TRANSMITTAL OF THE RESPONSES TO ADDITIONAL AGENCY COMMENTS TO THE SAMPLING AND ANALYSIS PLAN FOR THE SITE CHARACTERIZATION OF THE 903 DRUM STORAGE AREA, 903 LIP AREA, AND AMERICIUM ZONE - JEL-011-98

***Sampling and Analysis Plan
for the
Site Characterization of the 903 Drum Storage Area
903 Lip Area, and Americium Zone***

Responses to Additional Agency Comments

Response to Additional Comments from Colorado Department of Public Health and Environment, Hazardous Materials and Waste Management Division, on the Sampling and Analysis Plan for the 903 Drum Storage Area (IHSS 112), 903 Lip Area (IHSS 155), and Americium Zone, dated September 18, 1997 (Revision 0).

Well 8891 Time Series

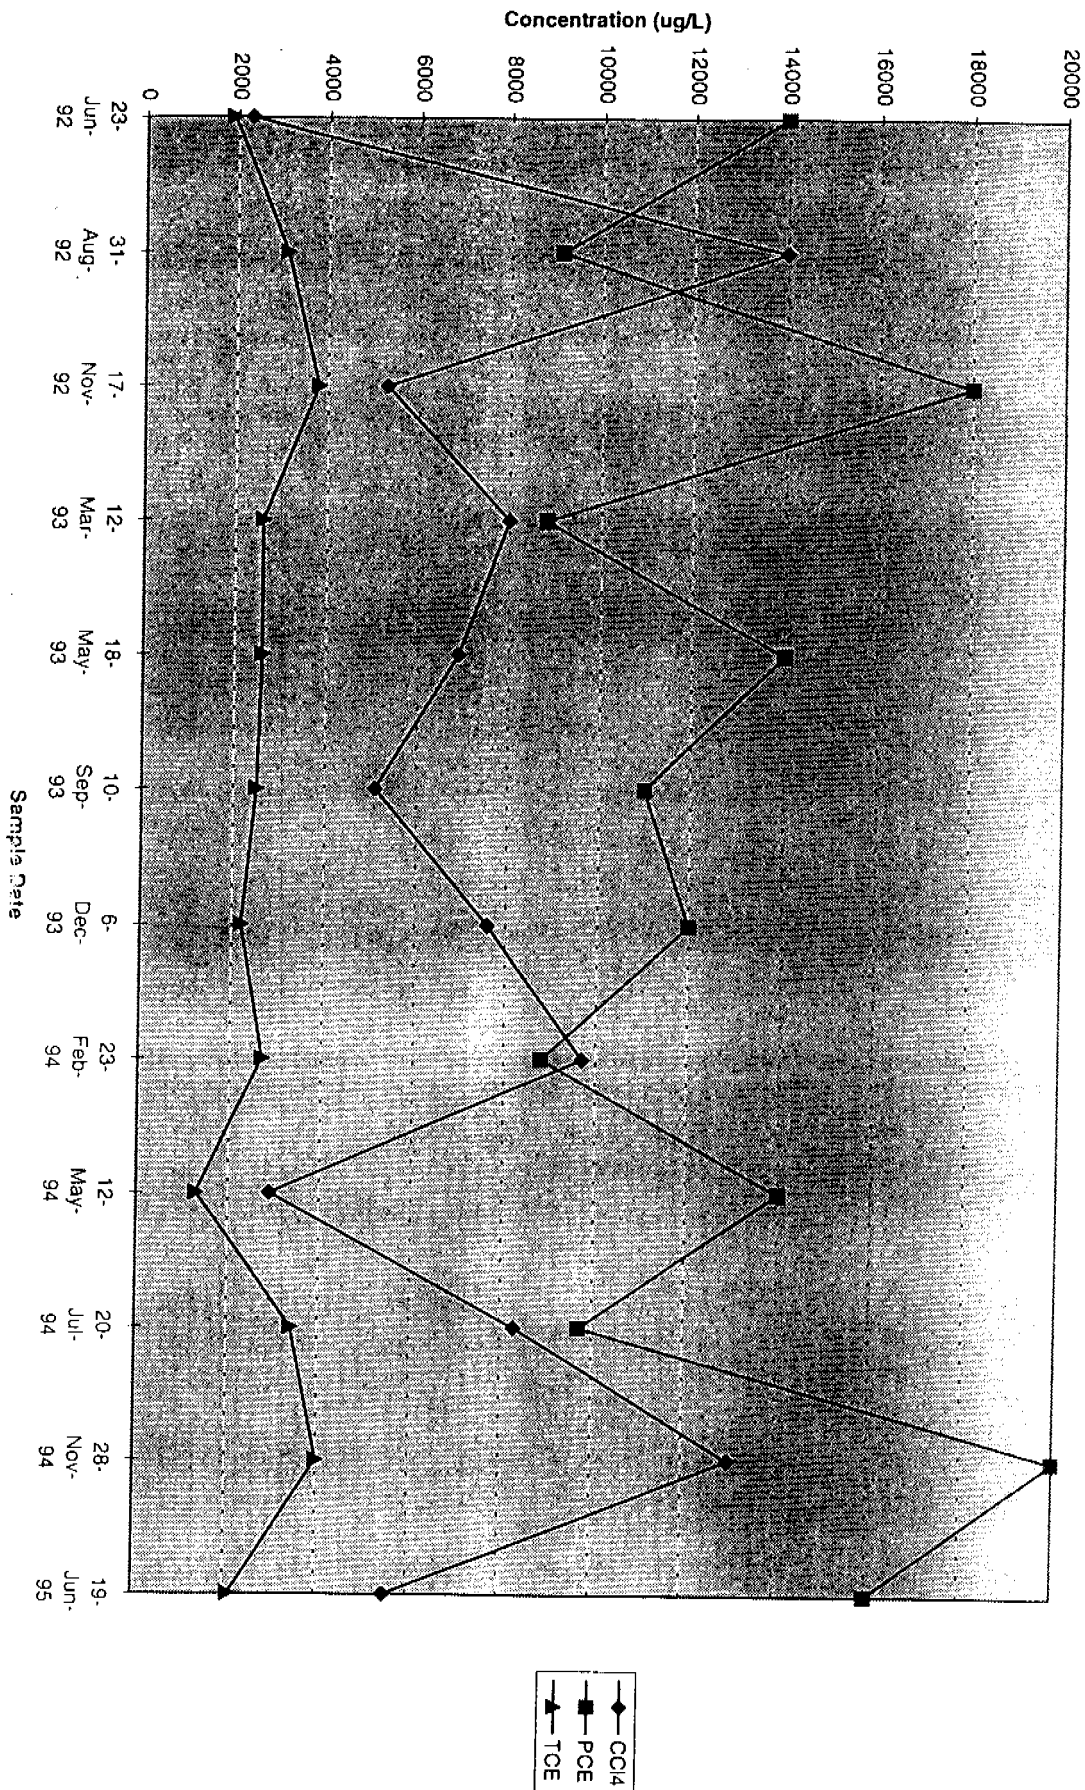
Section 1.2.3 provides background and a basis for additional groundwater investigations, but does not seem to be based on all the available data. Existing groundwater data should be presented in time series and evaluated. An evaluation should include whether VOC concentrations at a well are increasing or decreasing with time and whether concentrations increase with depth. Any pertinent data from soil or bedrock samples should also be presented.

A discussion of the time series evaluation of the VOC concentrations in well 6691 and 8891 was omitted from the text in the SAP because there is no significant change in concentrations over time. The attached time series chart for well 8891 reflect continuous concentrations of PCE, CCl₄, and trichloroethene. The attached time series chart for well 6691 reflect an overall slight increase in the concentration of CCl₄ over time. The CCl₄ concentration from well 6691 are well above one percent of the solubility of CCl₄. The data from both wells indicate a nearby upgradient source for the VOC contamination. The subsurface VOC investigation is designed to locate these sources.

Time Series, Well 6691

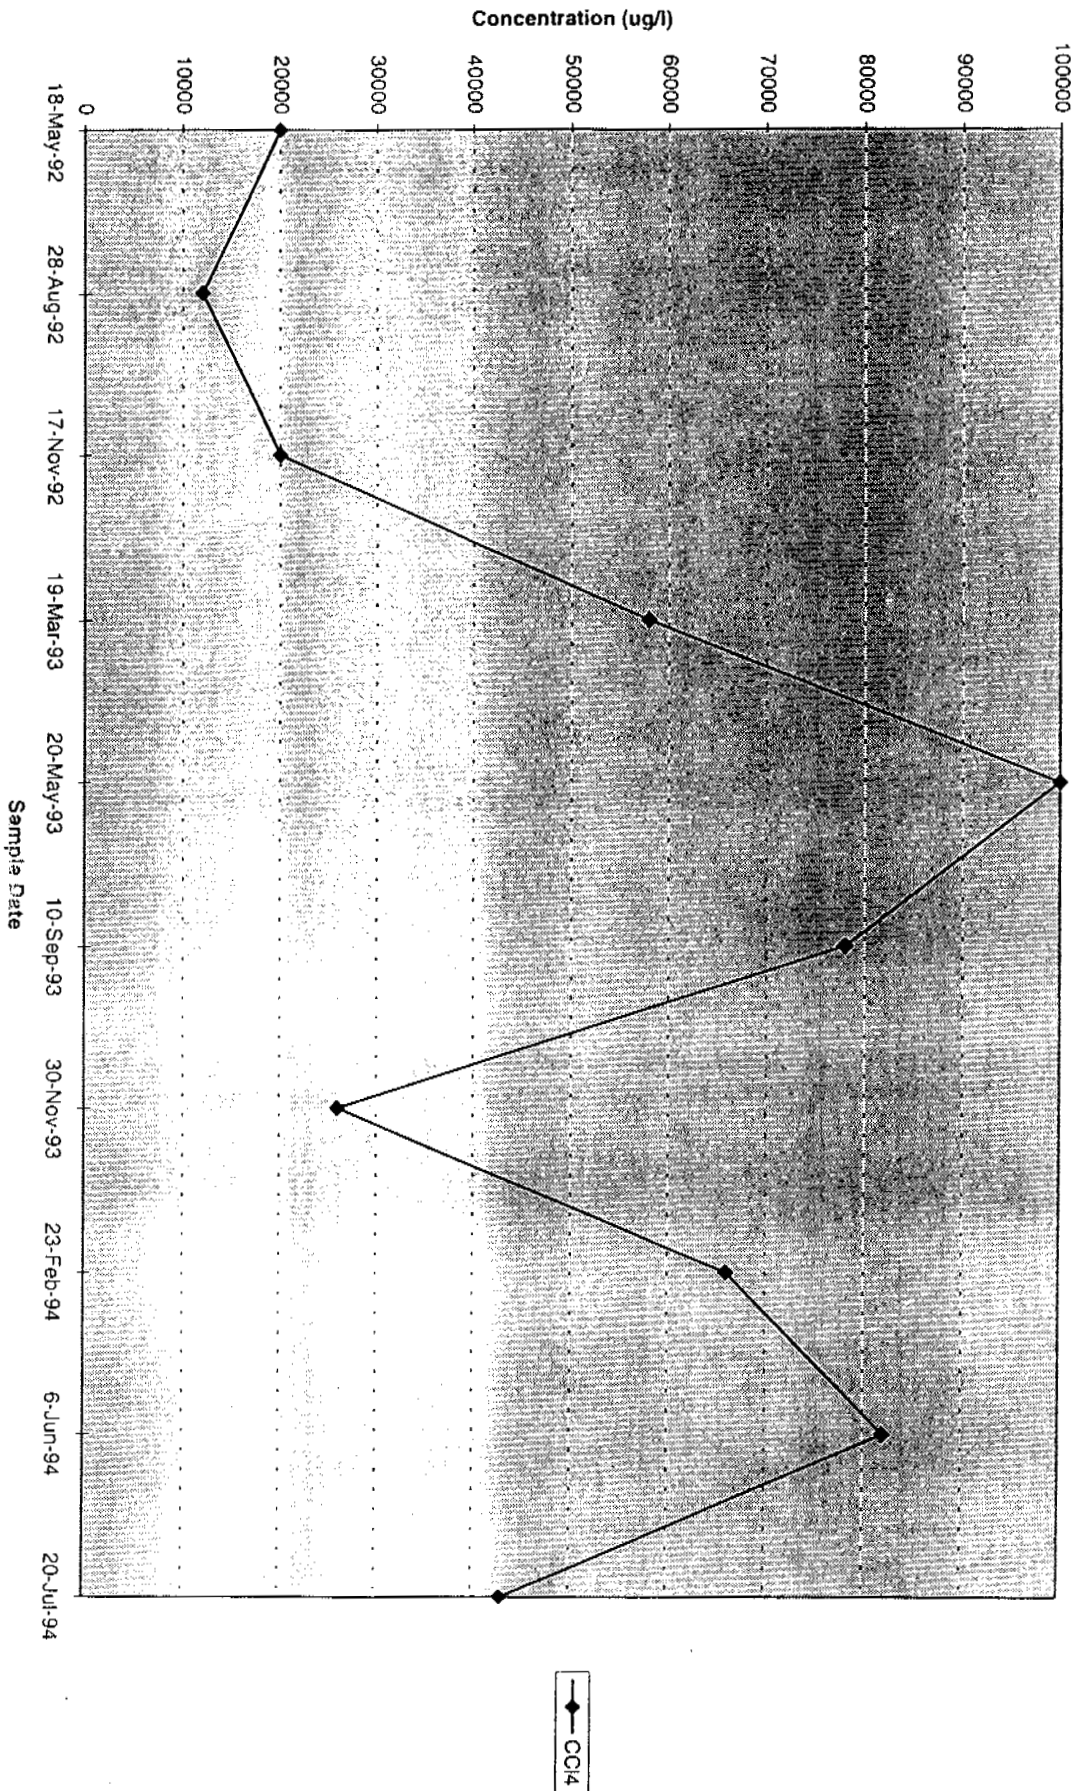
Section 1.2.3 provides background and a basis for additional groundwater investigations, but does not seem to be based on all the available data. Existing groundwater data should be presented in time series and evaluated. An evaluation should include whether VOC concentrations at a well are increasing or decreasing with time and whether concentrations increase with depth. Any pertinent data from soil or bedrock samples should also be presented.

A discussion of the time series evaluation of the VOC concentrations in well 6691 and 8891 was omitted from the text in the SAP because there is no significant change in concentrations over time. The attached time series chart for well 8891 reflect continuous concentrations of PCE, CCl₄, and trichloroethene. The attached time series chart for well 6691 reflect an overall slight increase in the concentration of CCl₄ over time. The CCl₄ concentration from well 6691 are well above one percent of the solubility of CCl₄. The data from both wells indicate a nearby upgradient source for the VOC contamination. The subsurface VOC investigation is designed to locate these sources.
